RA24LEU

F025102

Przewodnik Dokumentacji Technicznej

n1025065: Giugiaro-Vossloh thermostat box kit (low Ambient Temp. +16°C)

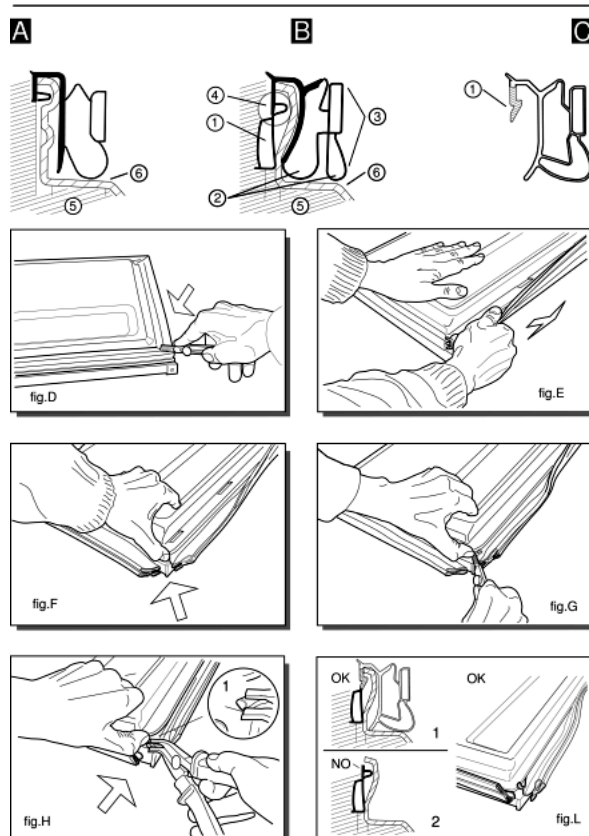
As of February-2001 (serial no. 10201.0001), the "thermostat box KIT for low ambient temperatures" is being handled with part number 076283 and is to be used on Indesit brand double-door refrigerators that have the Giugiaro thermostat box fitted on them

The kit is innovative, as it has a 6.6 Watt resistance fitted inside the thermostat box that should be activated by the toggle switch with a rubber protection situated underneath the thermostat knob. The switch is activated when the ambient temperature drops below +13°C (contacts closed. See the wiring diagram included in the kit).

On the thermostat box, the resistance is glued onto an aluminium plate (152x42) itself glued to the box.

Moreover, the thermostat box in the kit was obtained from the Giugiaro one (066229) with the Vossloh lamp holder and the Eltek switch. On this box, the position of the fixing hole was moved 15 mm up; therefore, on the models that are fitted with the Giugiaro thermostat box (048503), the hole on the cabinet should be remade before mounting the kit.

When replacing the thermostat box, no components should be re-used, and this includes the wiring.

The wiring in the kit has terminals with fastons for connecting them to the compressor's terminal board; in the event of different solutions, then make the suitable adjustments as necessary.

N1025158FIG1

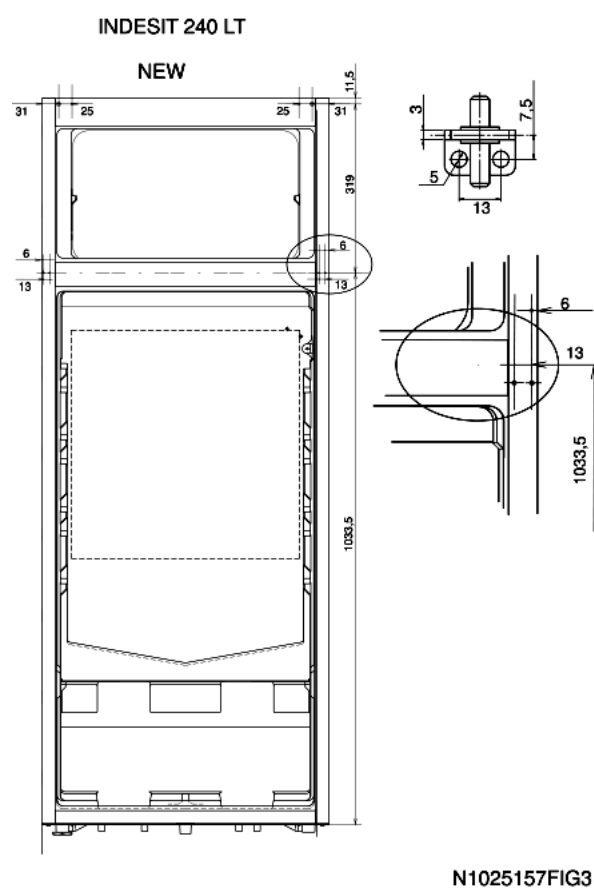
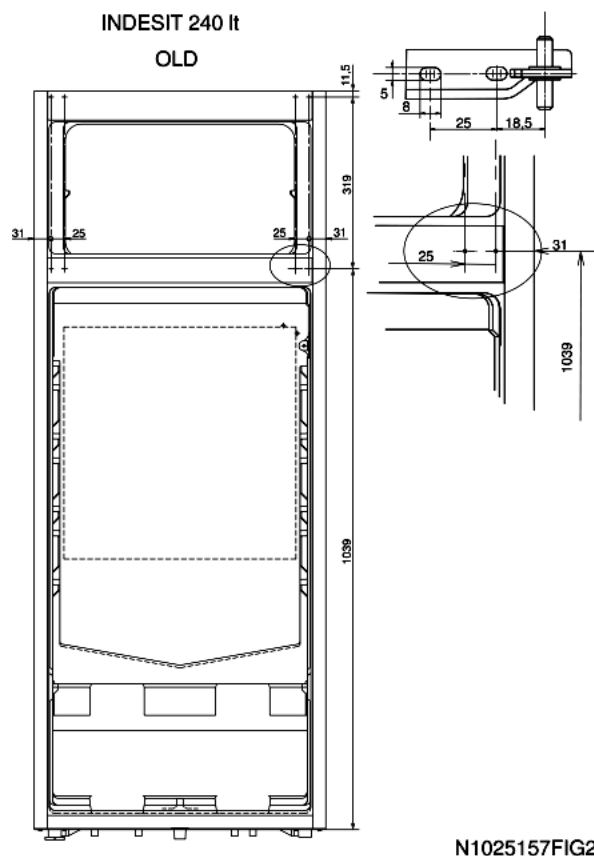
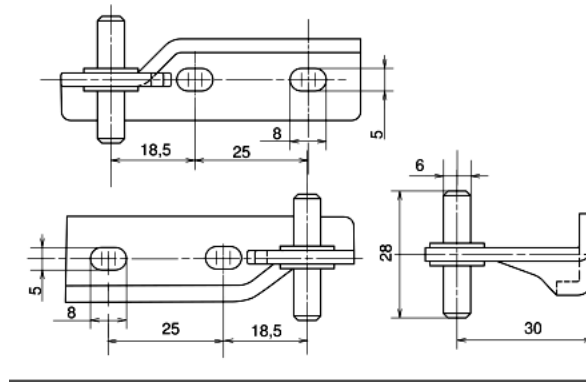
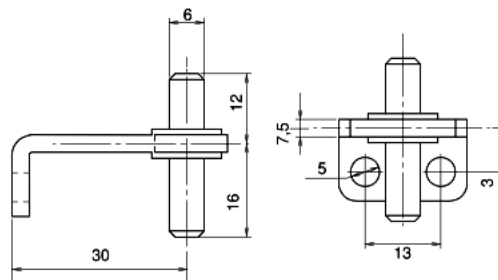
Od numeru 60123.0001 produkcja w Carinaro została zmieniona, w chłodziarkach o pojemności 240 l, obudowa, w której

wprowadzono nowy zawias centralny (patrz rysunek N1025158fig1) mocowany na panelu bocznym. Ponadto wysokość drzwi chłodziarki mieniono z 1030 mm na 1028.

Zawias może być odwrócony, lecz nie można go montować na modelach sprzed zmiany, w których zawias był mocowany na centralnej ramie obudowy. (patrz rysunek N1025157fig2).

Zmieniając sposób otwierania drzwiczki z prawostronnego na lewostronny nie należy odwracać zawiasu, tak jak poprzednio, lecz wystarczy przenieść go na lewą stronę.

W celu zamocowania należy nadal wykonywać otwór w obudowie po lewej stronie (patrz rysunek N1025157fig3).

Uwaga - Drzwi o wysokości 1028 mogą być używane w modelach sprzed zmiany przy zastosowaniu podkładki 2 mm (028928 - 034618 - 036775) na zawiasie dolnym.

OLD 053838 - 053478 - 114624

NEW 141794 - 142760 - 142756
